## ADDENDUM

**ADDENDUM NO.:** 04  
**PROJECT NAME:** Emergency Medical Services (EMS) Addition  
**PROJECT NO.:** 07215  
**CONTRACT NO.:** C1611  
**DATE OF ISSUE:** July 31, 2024

### NOTICE OF CHANGES, MODIFICATIONS, OR CLARIFICATIONS TO CONTRACT DOCUMENTS

**L300**

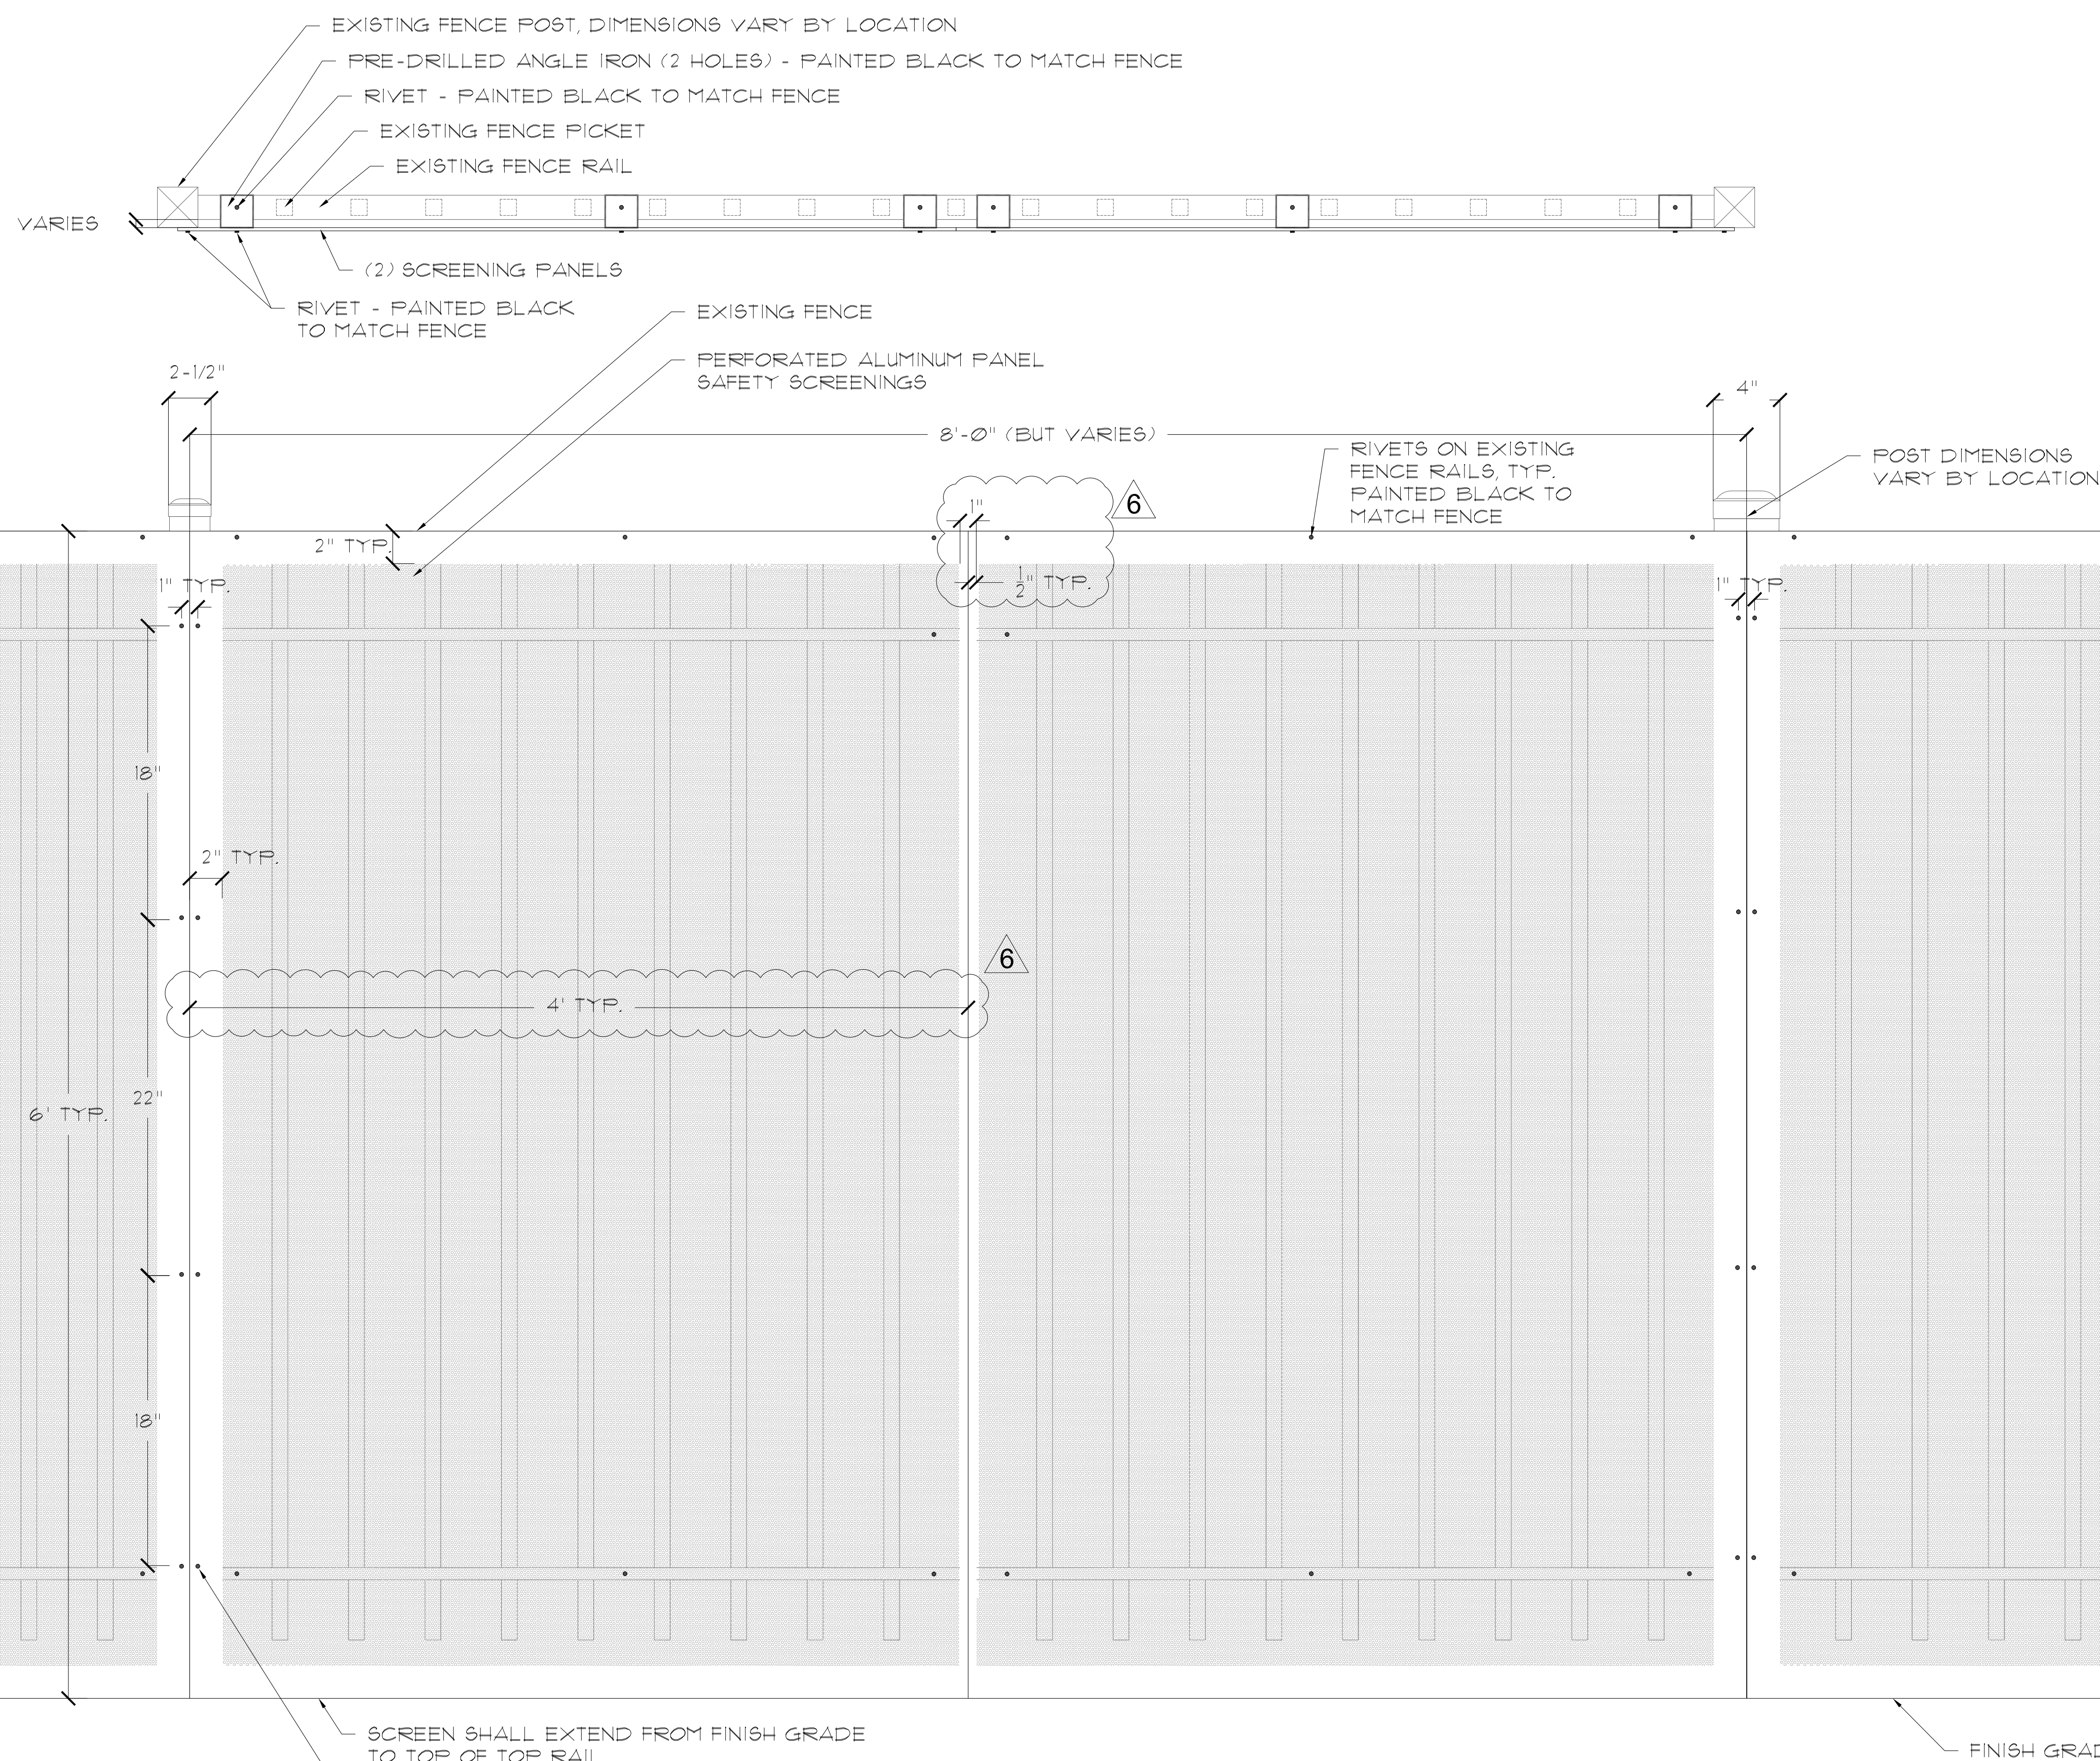
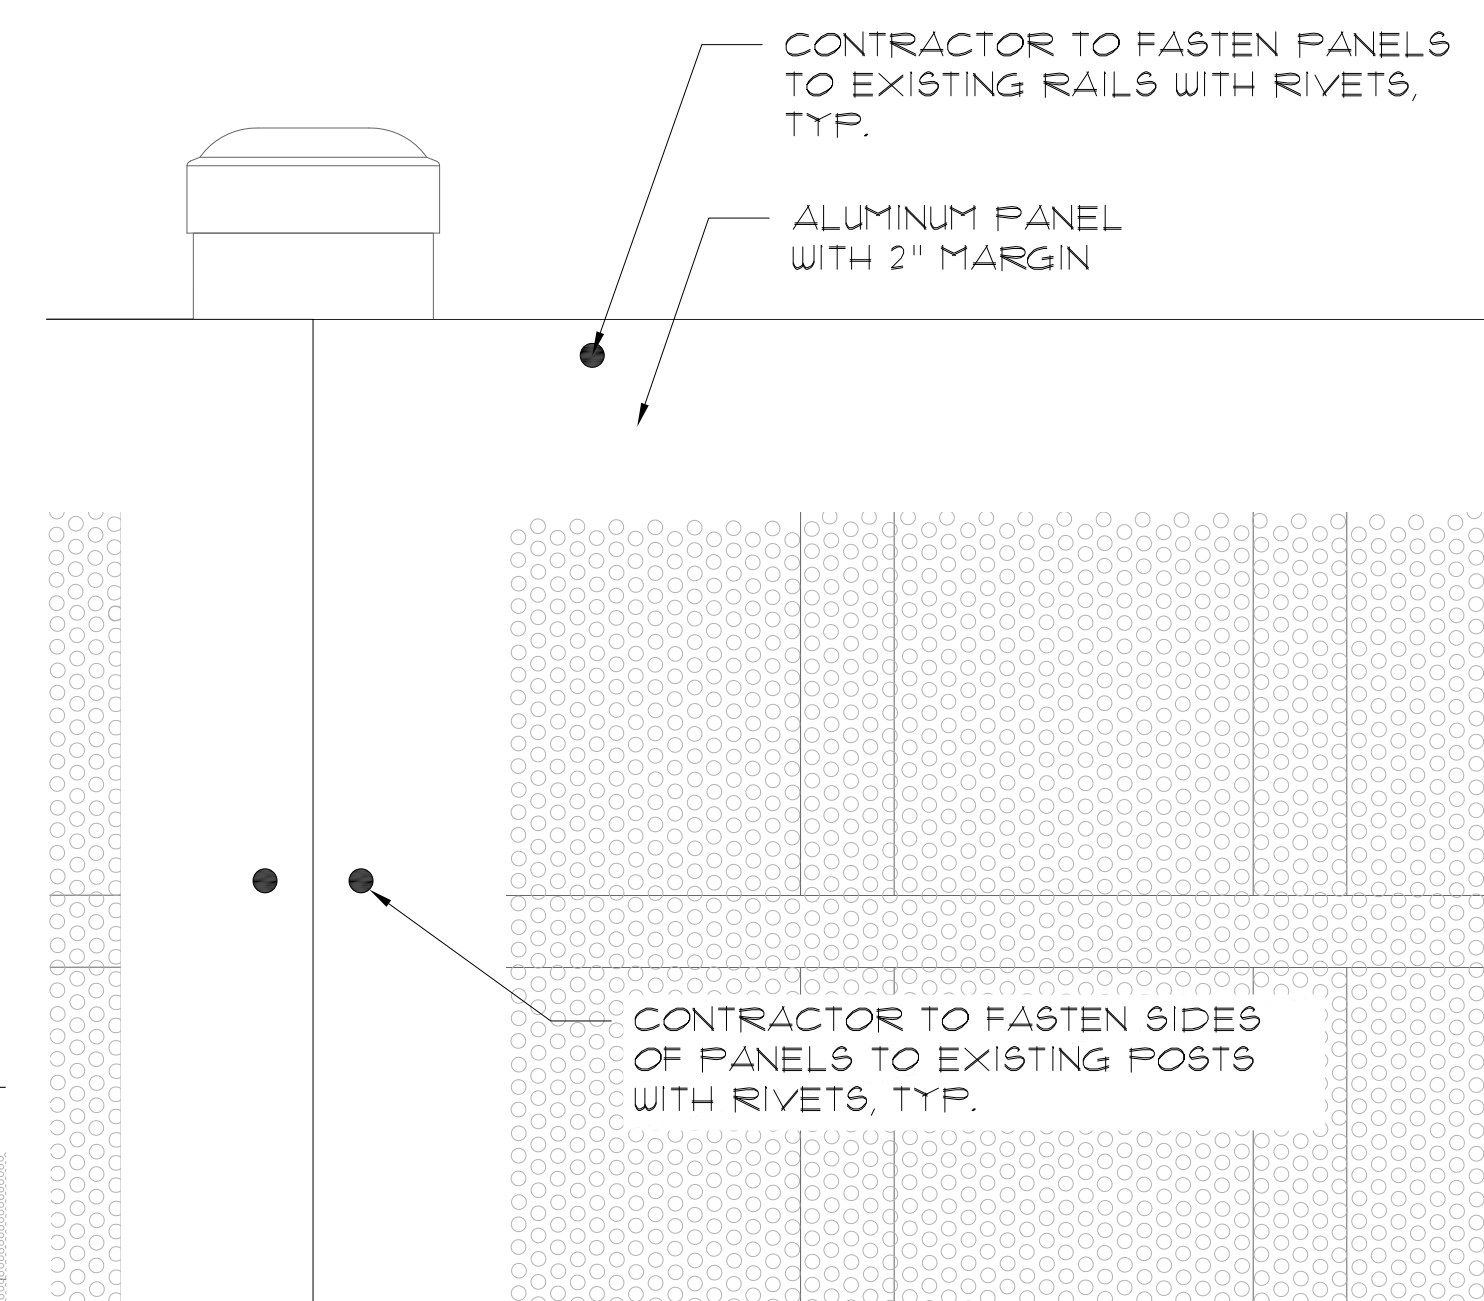
- Change 1** **REVISED** Drawing No. L300– Added more fence screening dimensions.
- Change 2** **REVISED** Drawing No. L301 – Updated text label for light traffic control on post.

**SHEET NUMBER**  
A164

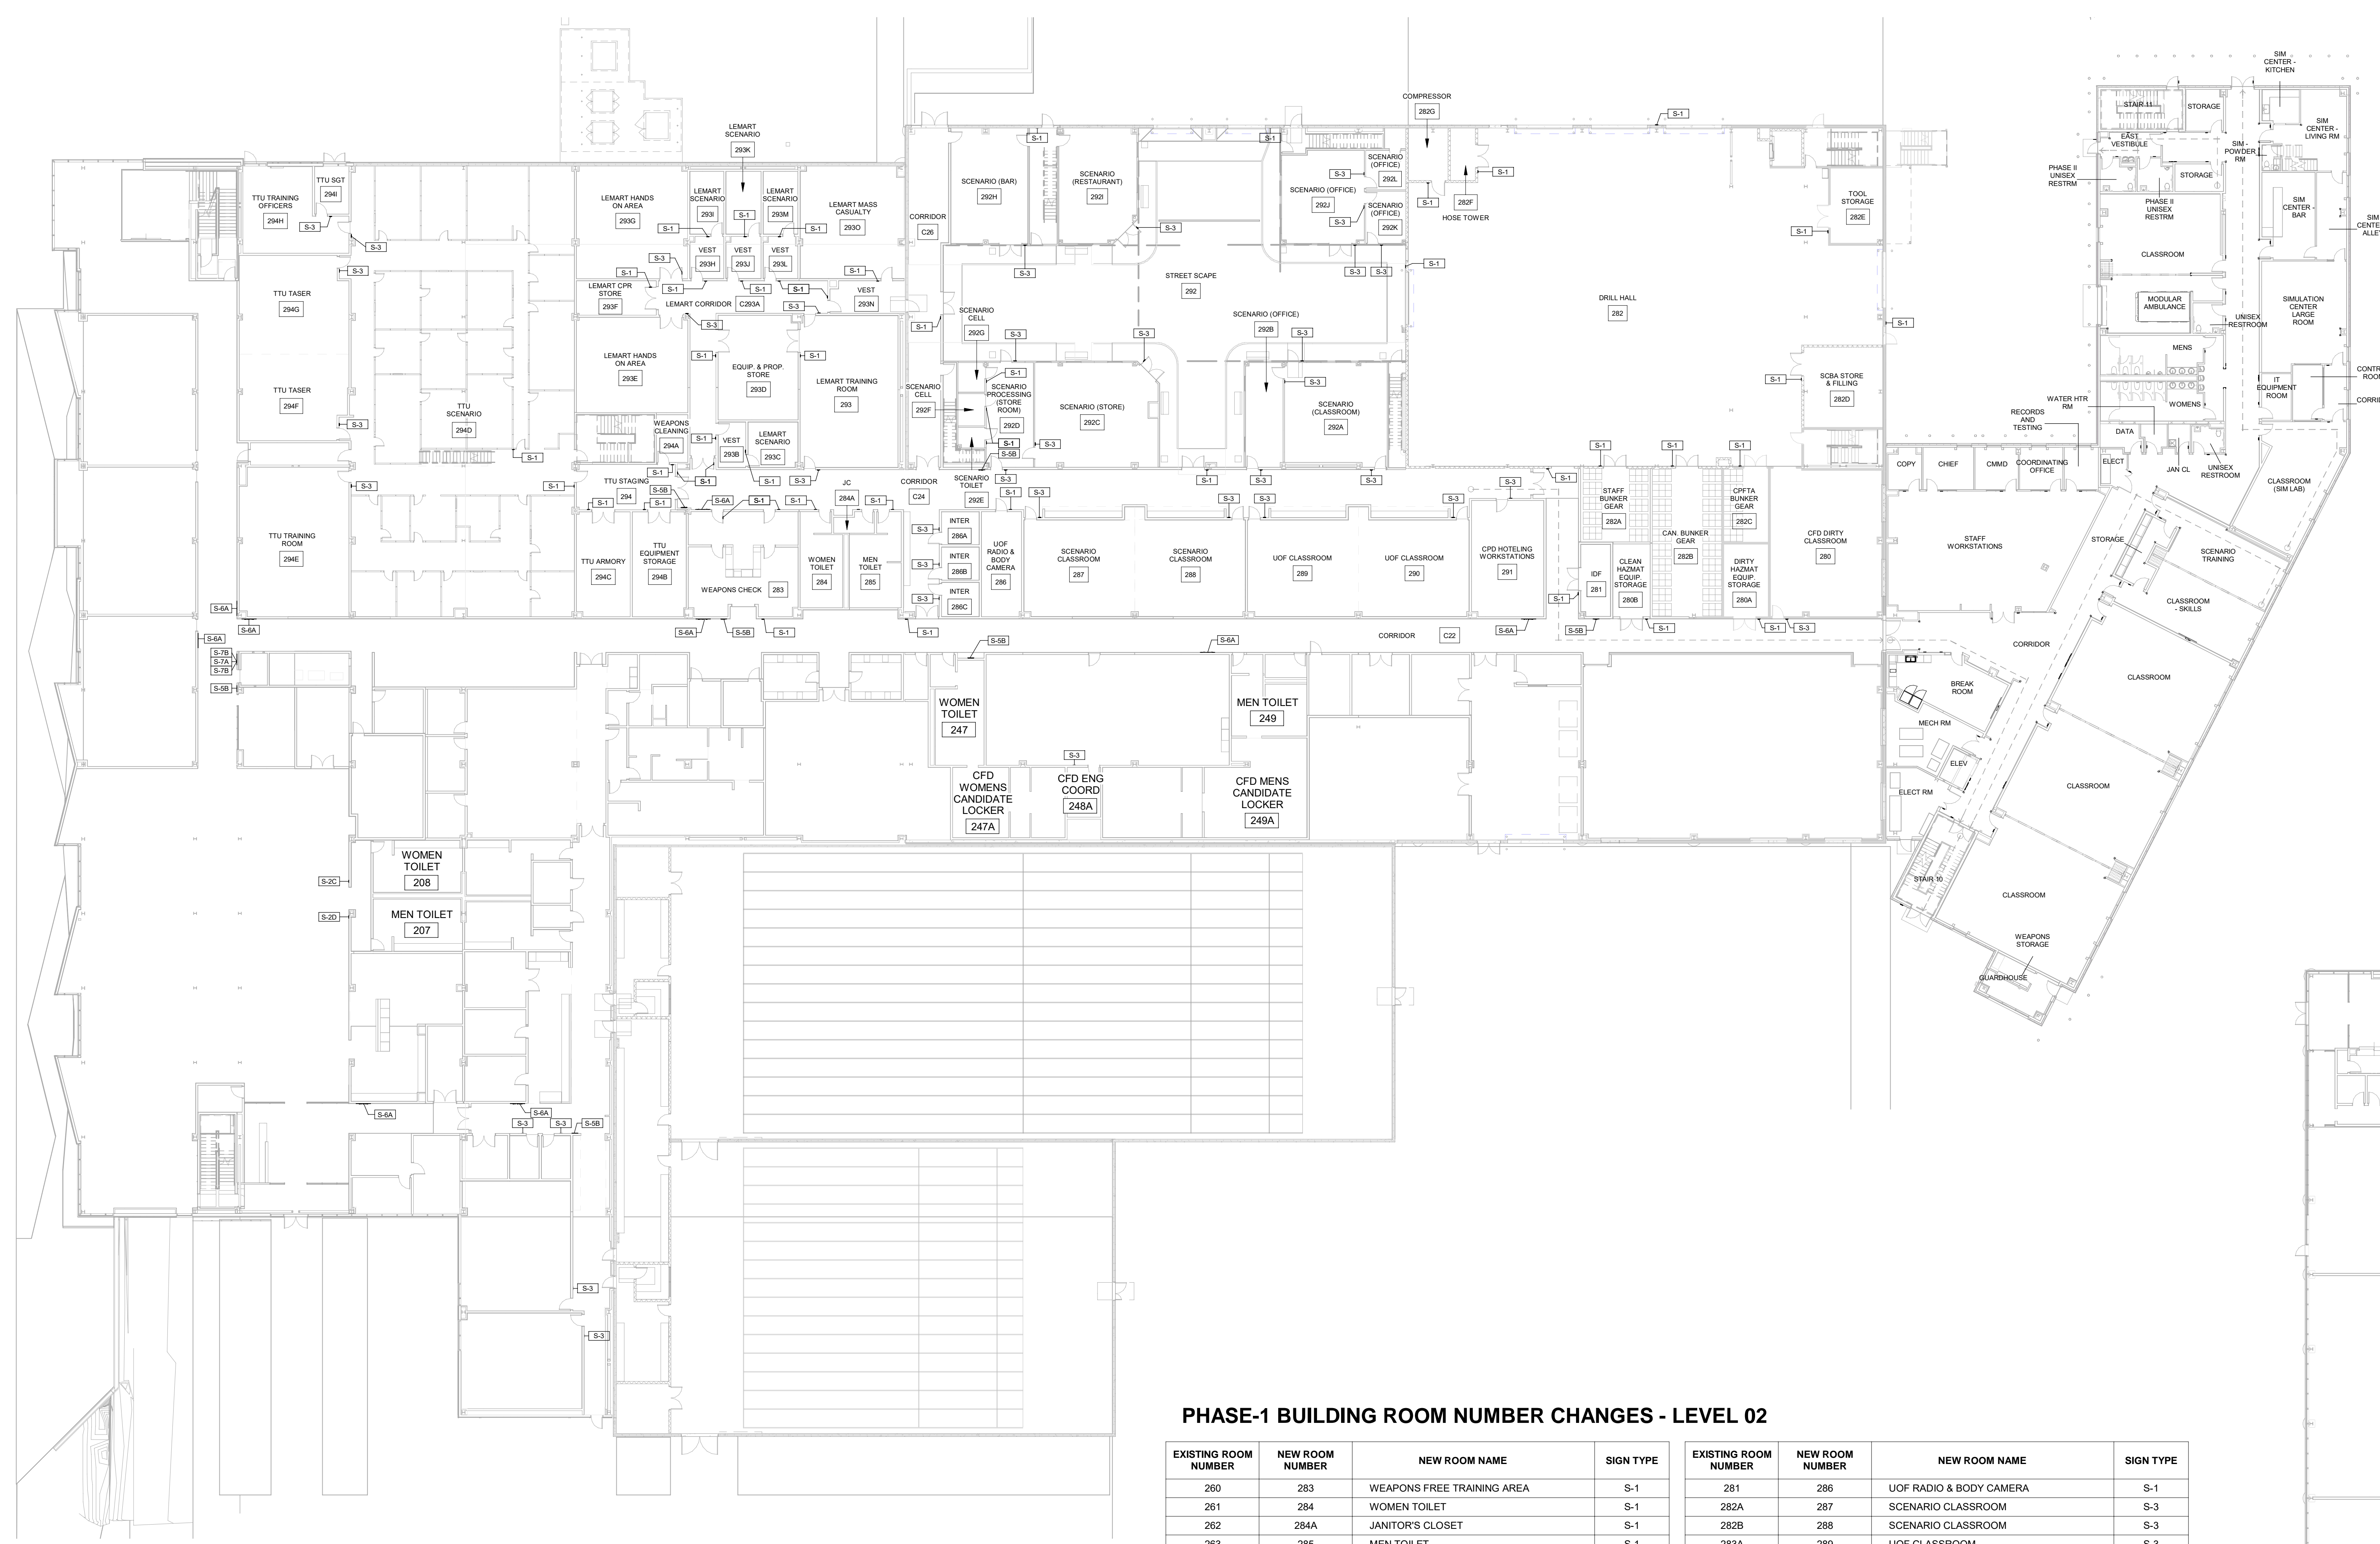
- Change 8** **REVISED** Drawing No. A164 – Restroom signs modified.
- Change 9** **REVISED** Drawing No. A320 - Updated Detail 1.
- Change 10** **REVISED** Drawing No. A401 – PL-1 tagged in restrooms.
